Planning Commission Staff Report

August 8, 2012
Item 5.b.

- SUBJECT:** P12-0801
- APPLICANT:** Eric and Michele Wall
- PROPERTY OWNER:** Eric and Michele Wall
- PURPOSE:** Application for design review approval to construct an approximately 6,200-square-foot residence with a habitable basement.

- GENERAL PLAN:** Low Density Residential (< 2.0 du/ac).
- ZONING:** PUD – LDR (Planned Unit Development – Low Density Residential) District.
- LOCATION:** 2505 Yolanda Court (Lot 5 of Tract 7499).

Figure 4: Proposed Site Plan

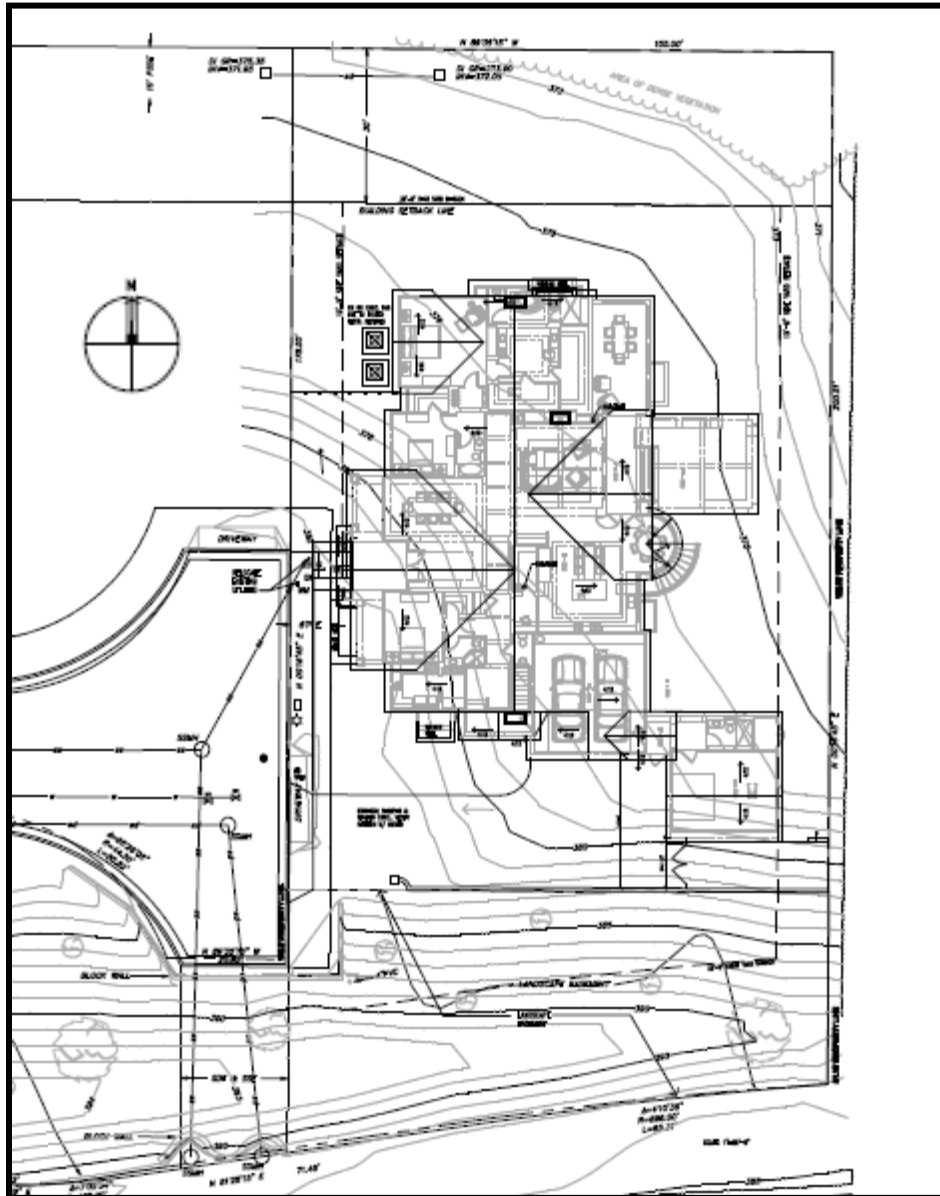
The proposed home is sited towards the west and south sides of the property so that the proposed basement would be excavated into the site, thereby reducing the height of the basement/foundation walls on the building's north and east sides, and to reduce the driveway grade so that it can be used as guest parking. Figure 4, below, is a copy of the proposed site plan.

The entrance to the proposed home faces the west property line with patios and yard areas on the north and east side of the proposed building. Although the front door faces west, staff considers the west property line as a side property line, the south property line by Vineyard Avenue as the front property line, the north property line by Shadow

The one- and two-car garages on the building’s south side provide a 25-foot back-out space to the edge of pavement. The driveway apron is an approximately 10-percent slope, which is acceptable to the City’s Building and Engineering Divisions and to the Livermore-Pleasanton Fire Department. The applicant will modify the existing driveway curb cut to Yolanda Court to accommodate the proposed driveway. Staff estimates that up to four guest vehicles can park in front of the garages in addition to the on-street parking that is allowed on the north side of Yolanda Court. The driveway material will be stamped, colored concrete with an “old granite texture” appearance.

applicant proposes up to 4-feet of fill on the east side of the property. The fill area would be retained by a 2-foot to 3-foot tall retaining wall on the east property line ending at the geotechnical setback line. A 5-foot tall retaining wall will be installed along the south side of the driveway apron where the proposed grading for the driveway apron will cut into the berm facing Vineyard Avenue.
